HISTORIC AND DESIGN REVIEW COMMISSION

HDRC CASE NO: 2018-099
ADDRESS: 1418 FULTON AVE
LEGAL DESCRIPTION: NCB 2752 BLK 58 LOT 8
ZONING: R-4 H
CITY COUNCIL DIST.: 1
DISTRICT: Fulton Historic District
APPLICANT: Tony Sanchez
OWNER: Tony Sanchez
TYPE OF WORK: Window replacement
APPLICATION RECEIVED: February 19, 2018
60-DAY REVIEW: April 20, 2018
REQUEST:

The applicant is requesting a Certificate of Appropriateness for approval to:

2nd Floor, Front

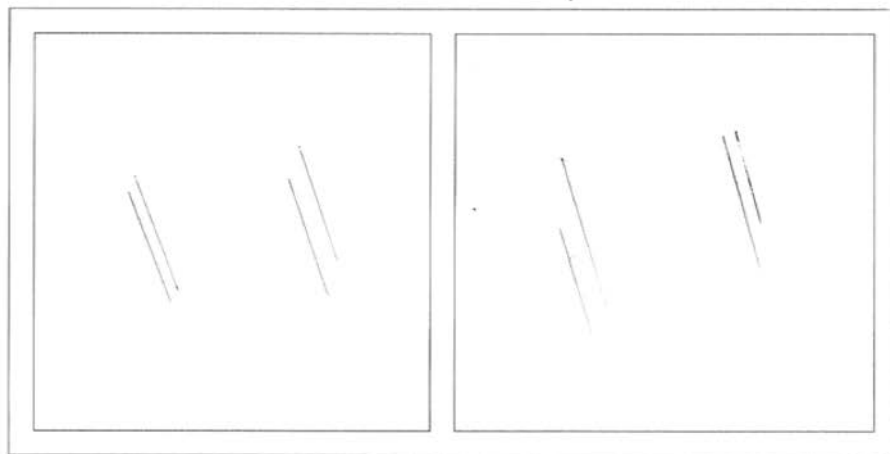
- c. **WINDOW REPLACEMENT: SECOND FLOOR** – The applicant is proposing to replace two second story wood windows featuring 8 divided lites with new wood windows featuring 2 divided lites. The second story of this structure is not original and non-contributing. According to the Historic Design Guidelines, existing wood windows should be preserved and restored. If the window is deteriorated beyond repair, the replacement window must match the appearance, materials, size, design, proportion, and profile of the original window. The existing windows are significantly deteriorated and eligible for replacement. However, the proposed replacement window, while matching in material, does not match the divided lite configuration of the existing. While the second story addition itself is not original, the design and configuration of the windows matches those on the first floor and those commonly found in historic Spanish Eclectic homes on Fulton Ave and in the nearby historic district Monticello Park. These windows may have been relocated from the first floor when the second story was added; alternatively, they were built to match the existing windows in all respects. Staff does not find the proposed replacement windows consistent with the Guidelines.

Staff does not recommend approval based on findings a through c. Staff recommends that the applicant installs new wood windows that match the dimensions, profile, materiality, and divided lite configuration as the existing. The applicant must submit updated drawings to staff that clearly indicate all dimensions, including overall size and individual muntins, for each opening.
